ADDENDUM NO: 01

PROJECT: Center Grove MS Central Renovation

PROJECT NO: 2024017 DATE: June 25, 2025 BY: Jack Leibham

DRAWING NUMBER A801E PROJECT NUMBER 2024017

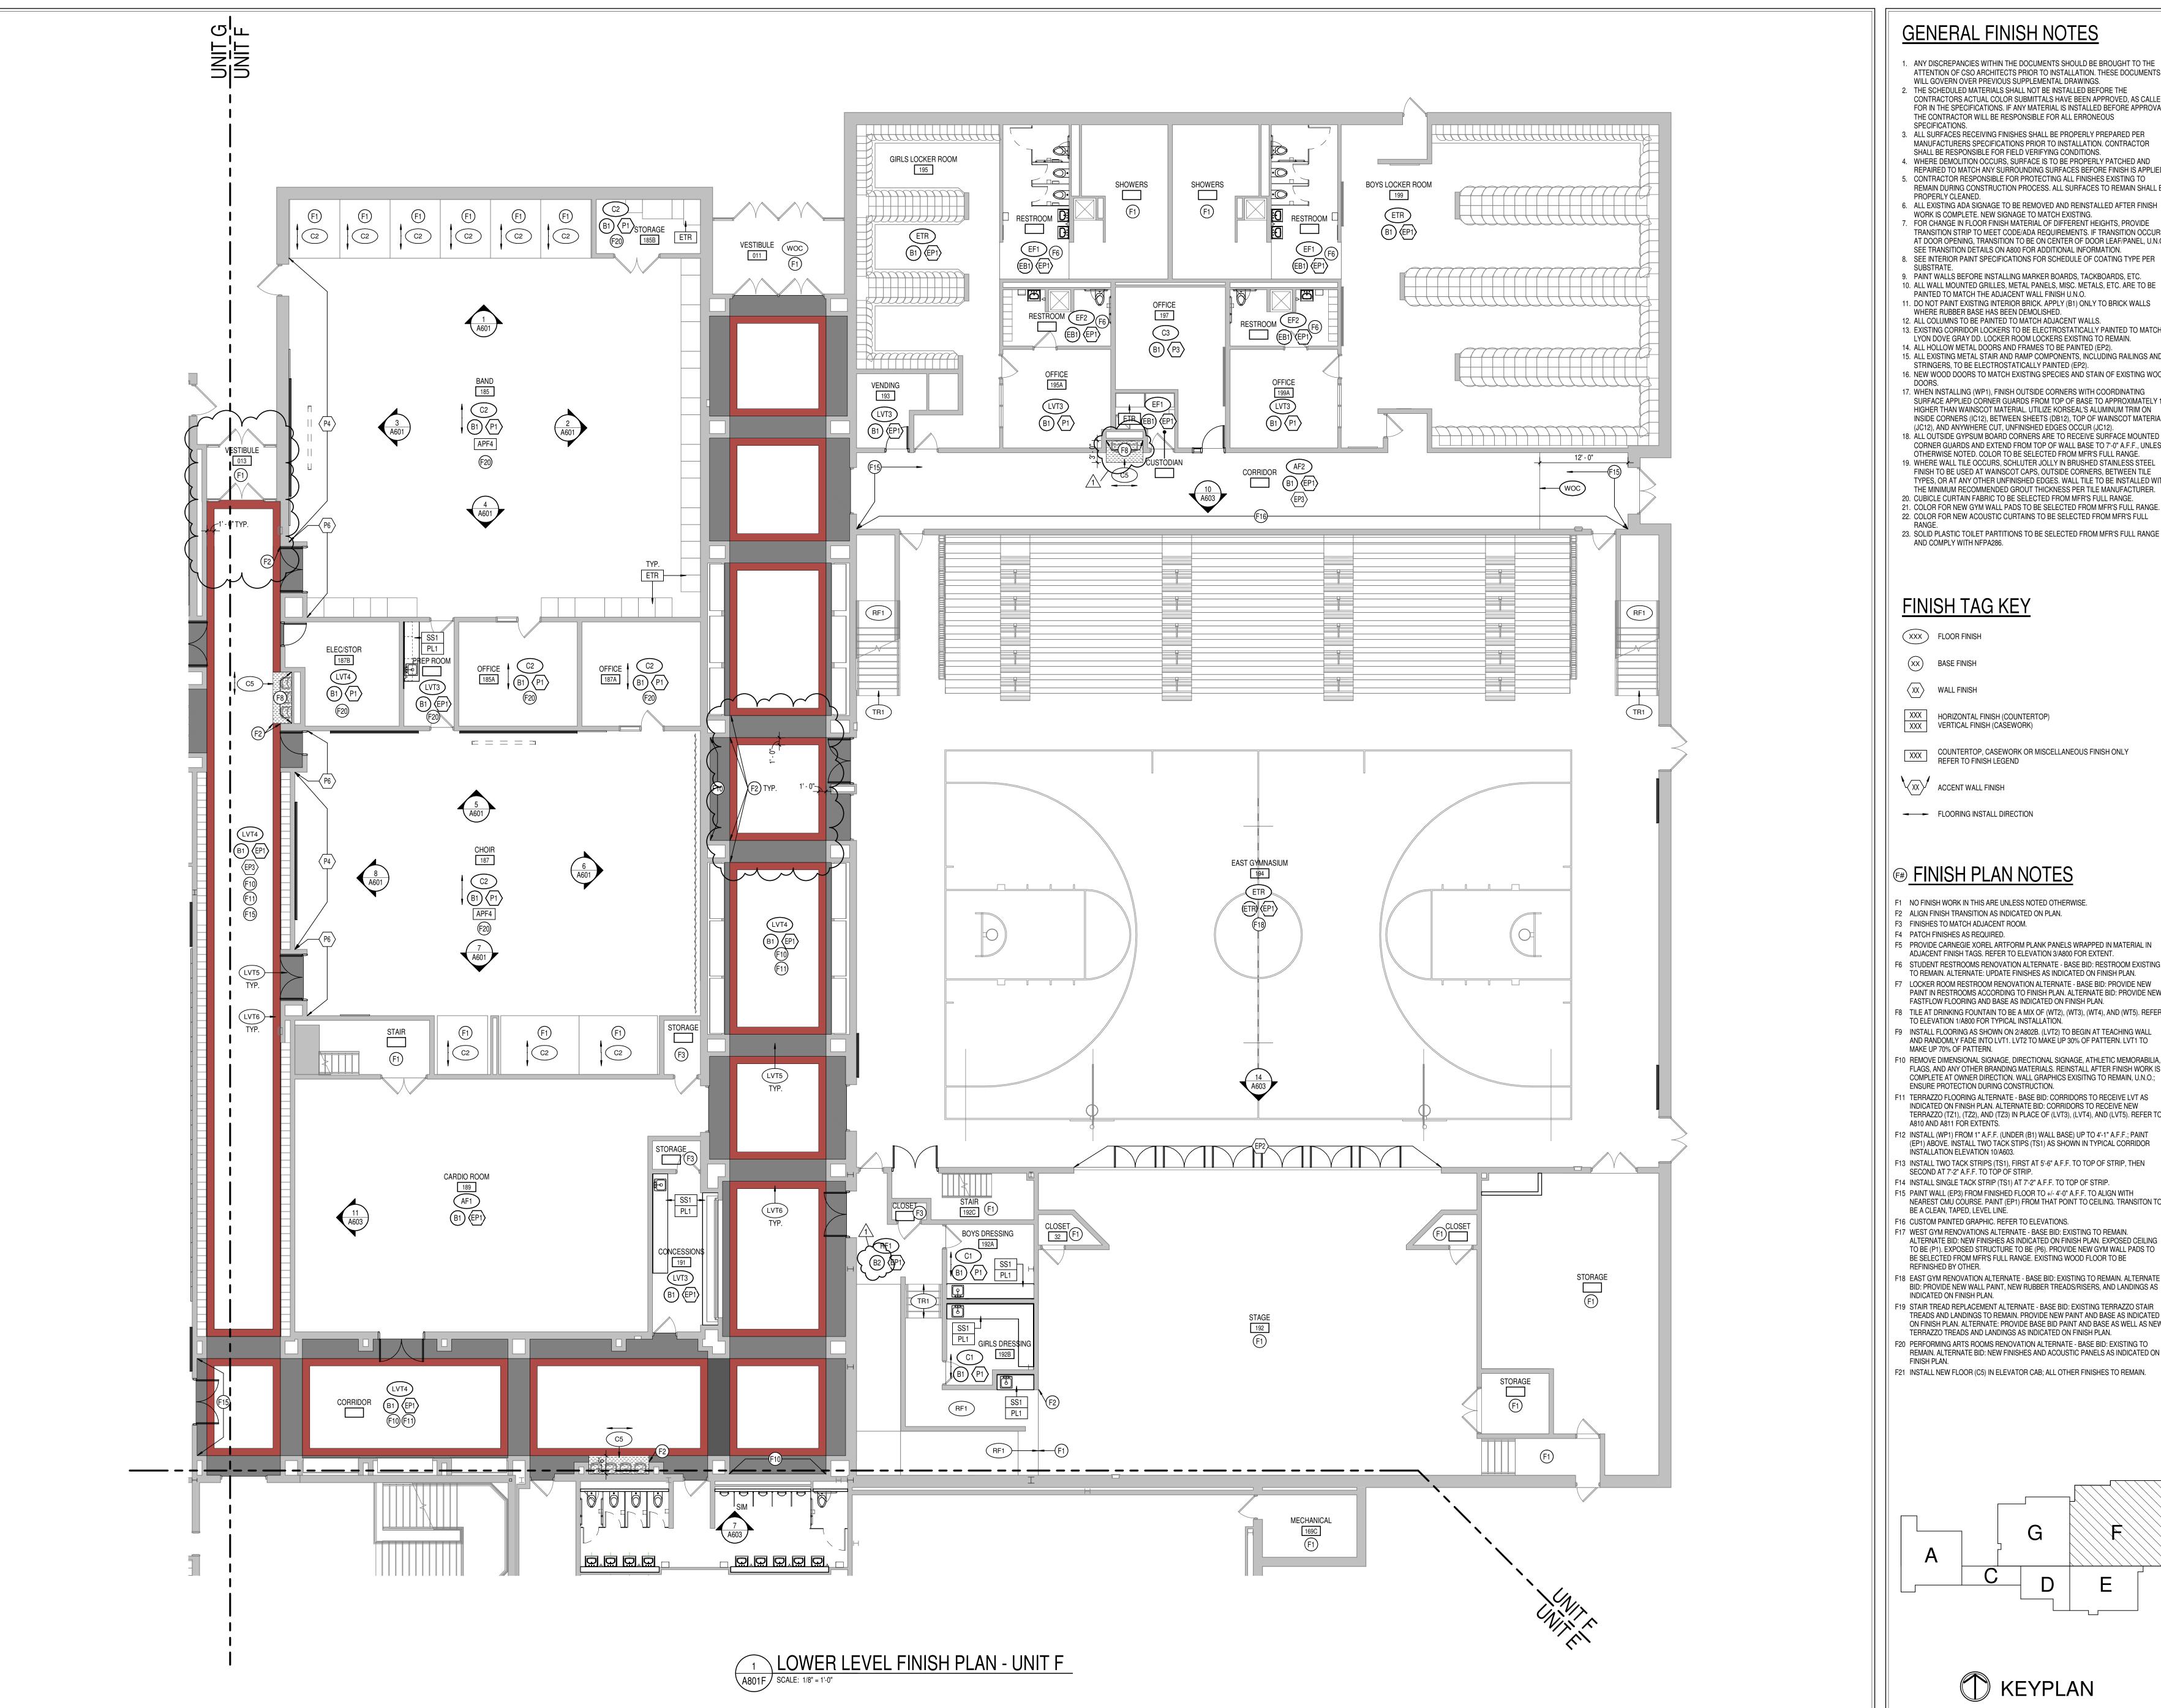
- A. Add F8 finish tag to drinking fountain alcove.
- B. Add F15 finish tag and EP3 wall tag to corridor as indicated.

DRAWING NUMBER A801F

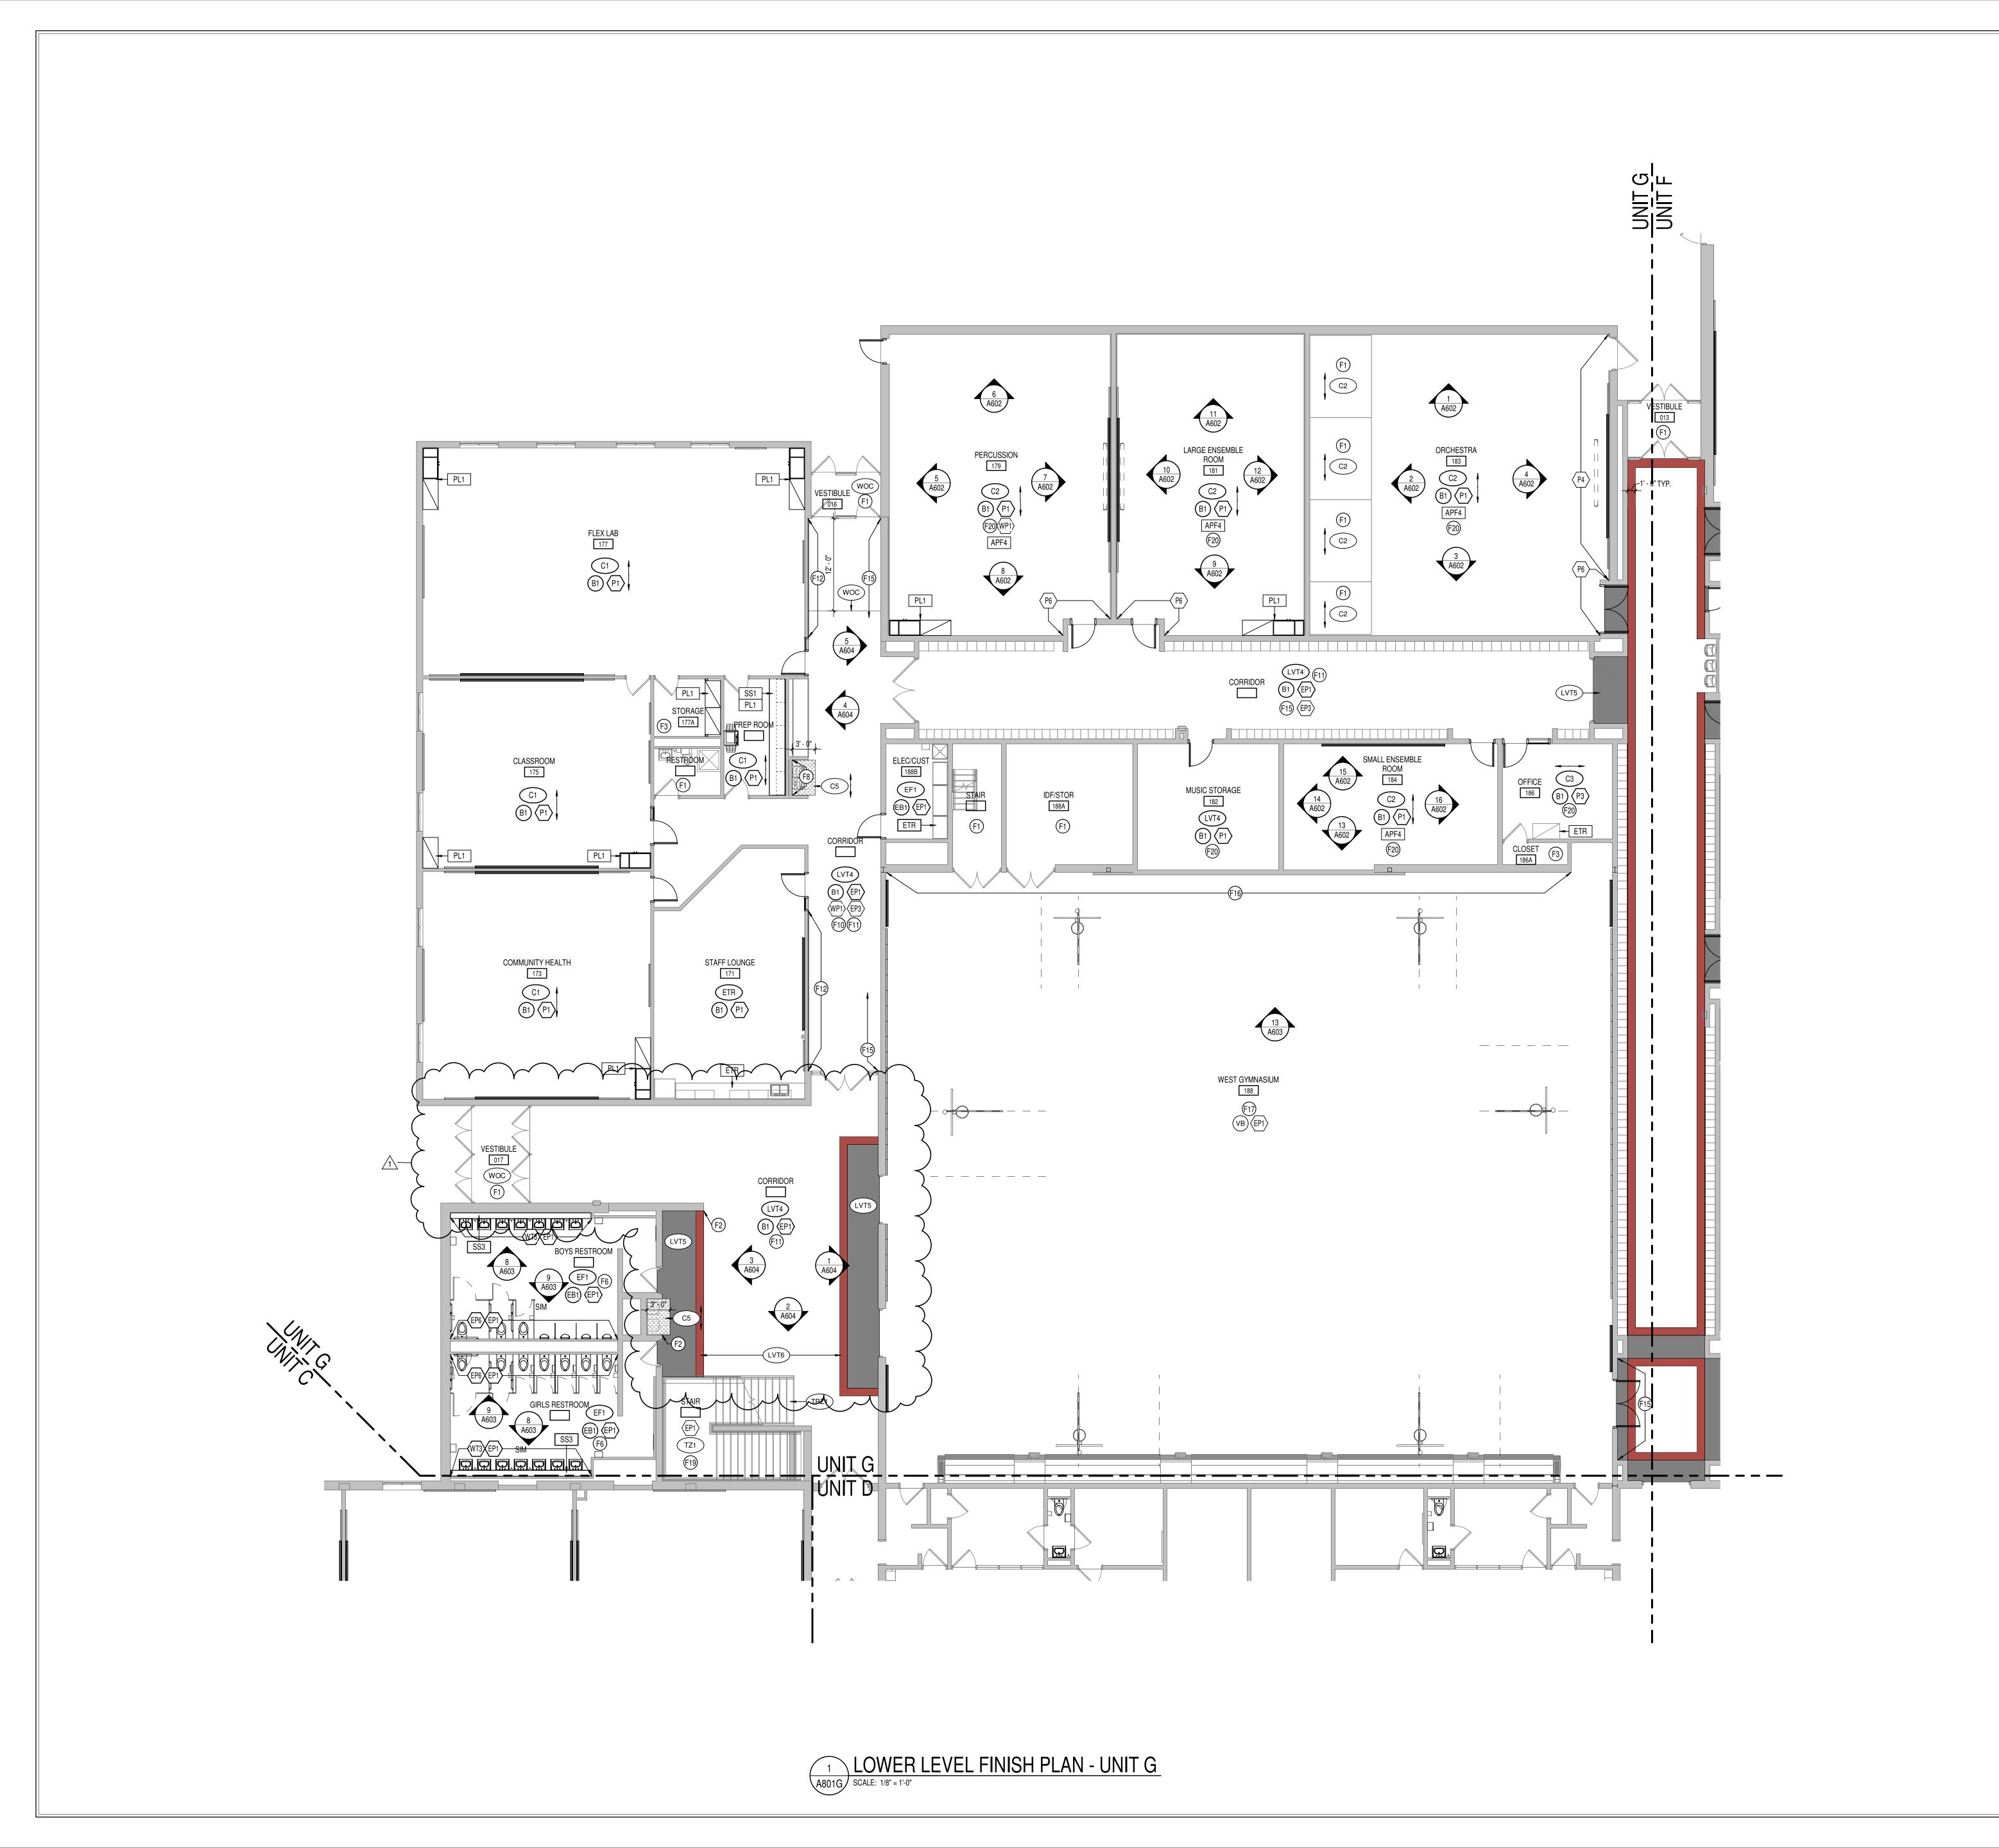
- A. Revise B1 to **B2** as indicated
- B. Revise extents of walk off carpet and LVT as indicated.
- C. Add dimensions and F2 finish note as indicated.
- D. Add F8 finish tag to drinking fountain alcove.

DRAWING NUMBER
A801G

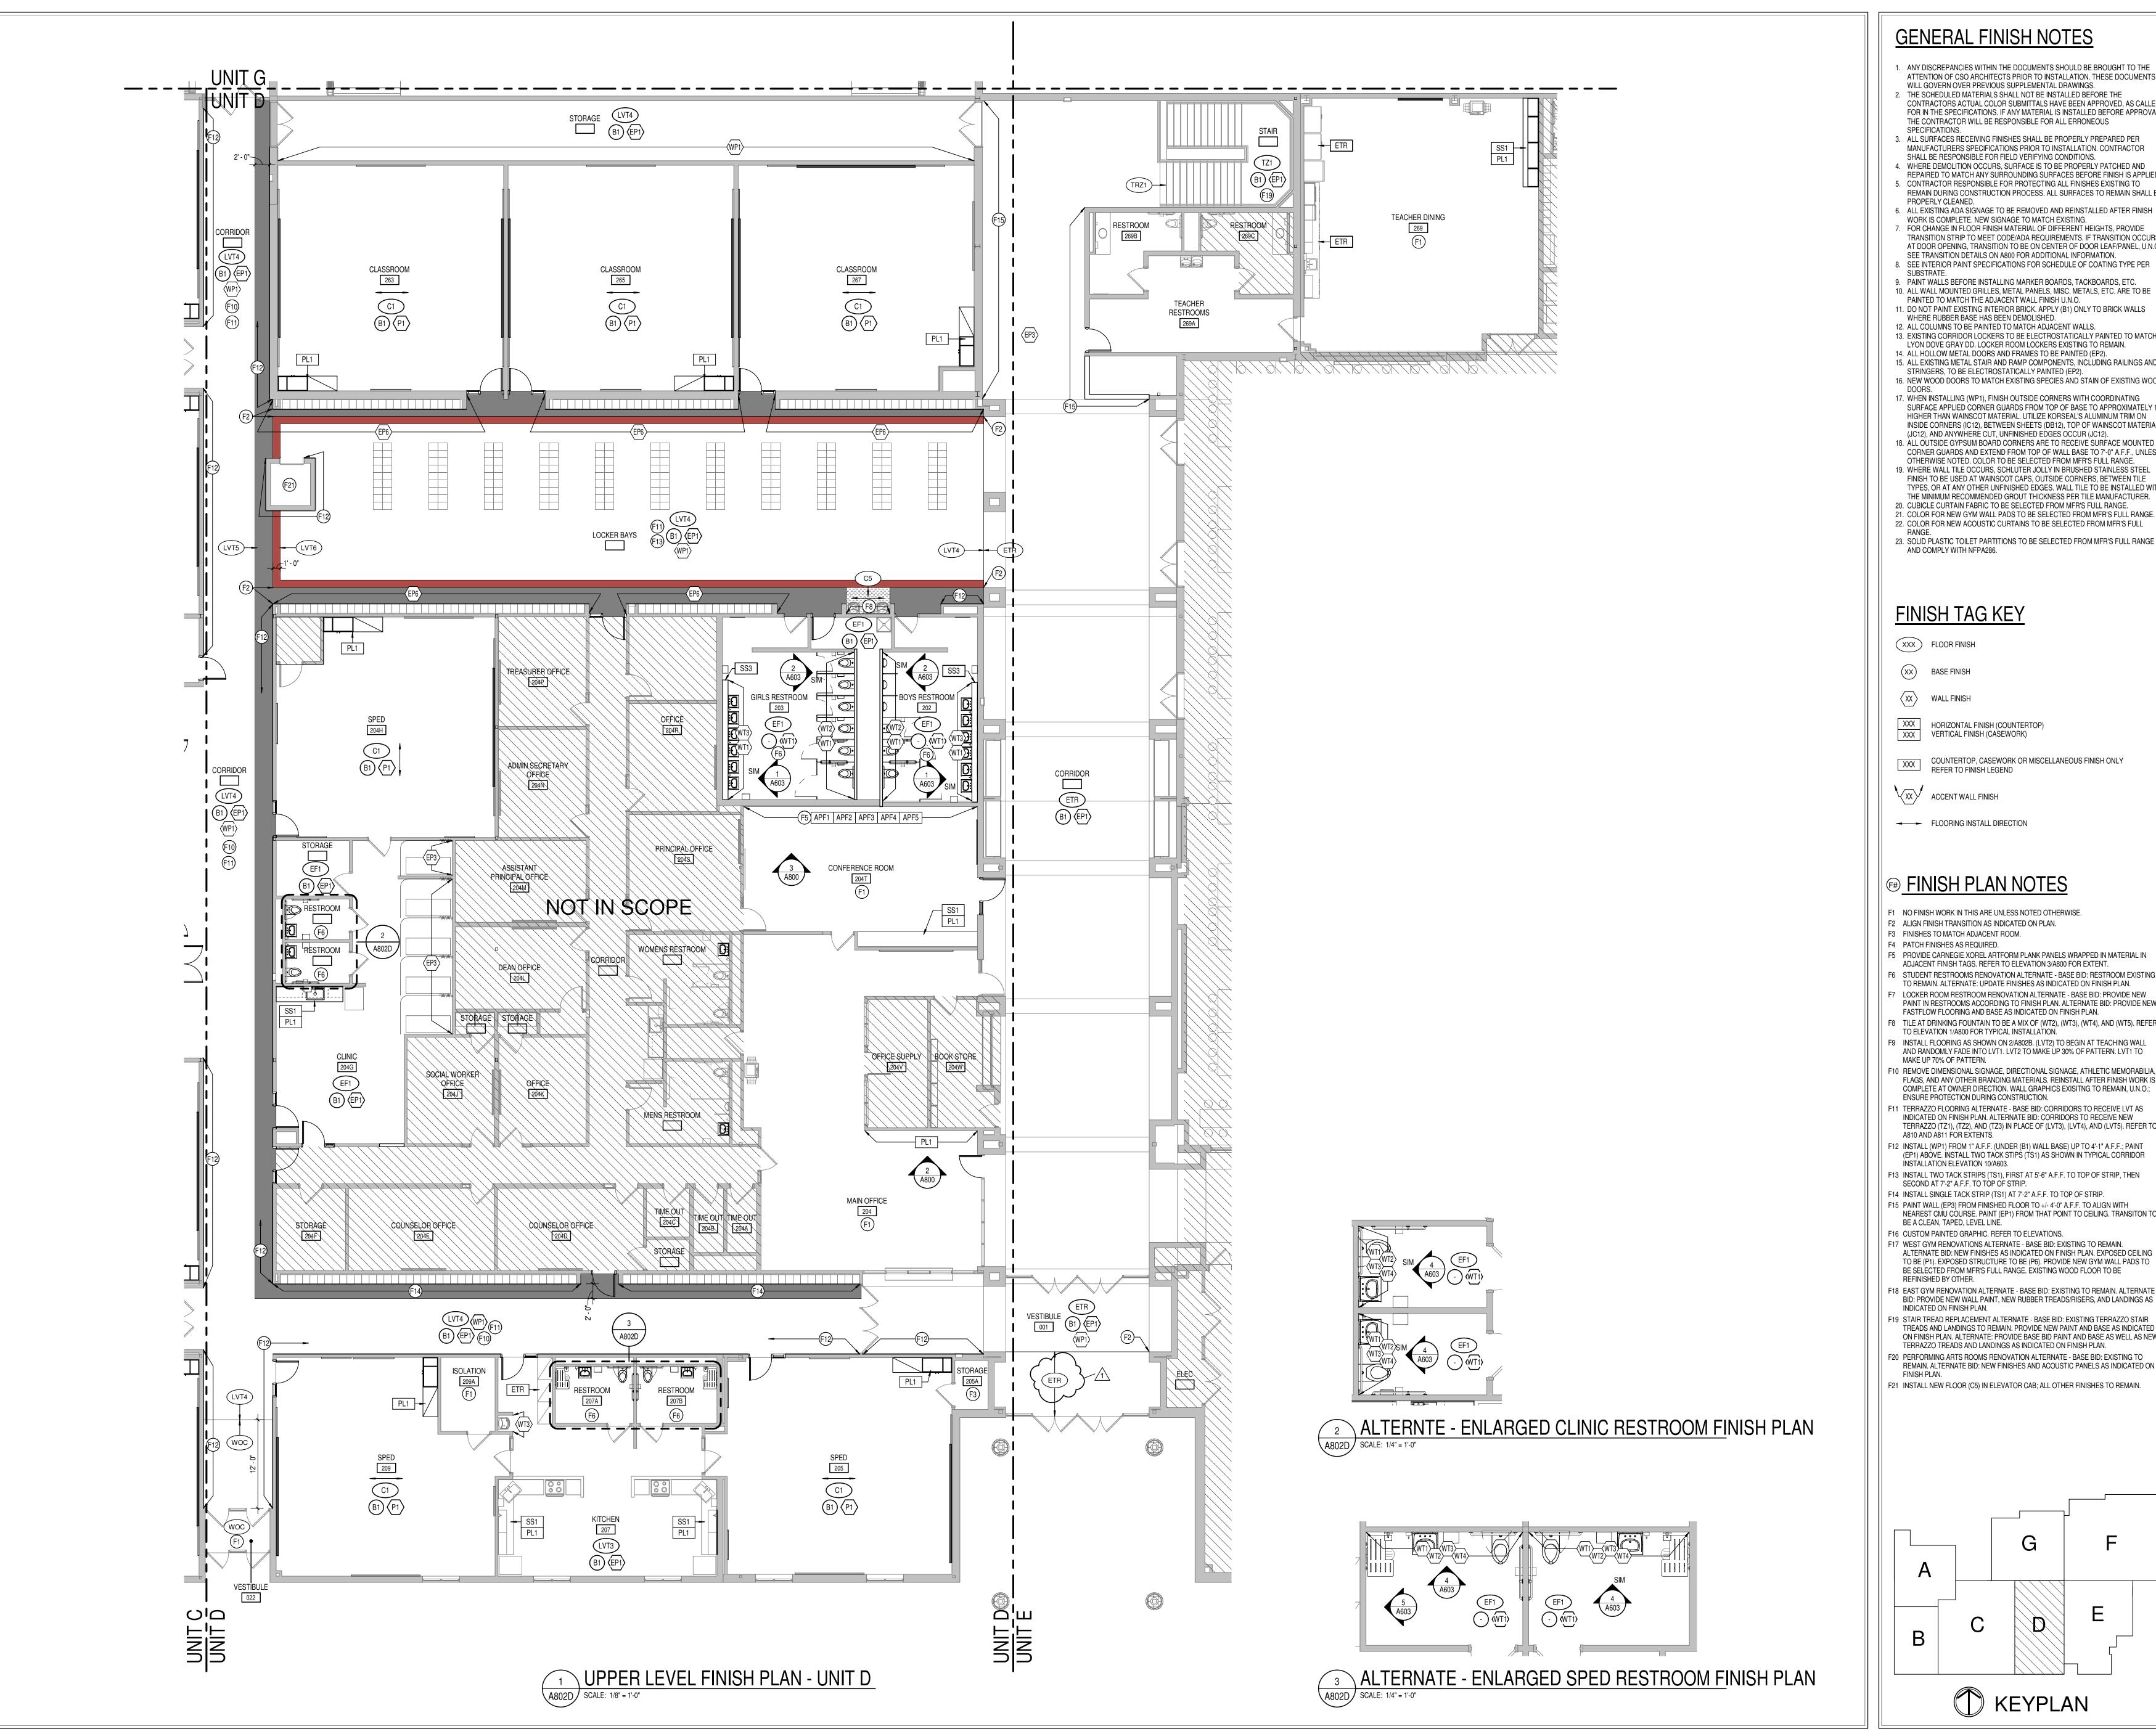
A. Revise walk off carpet extents and floor pattern plan as indicated.
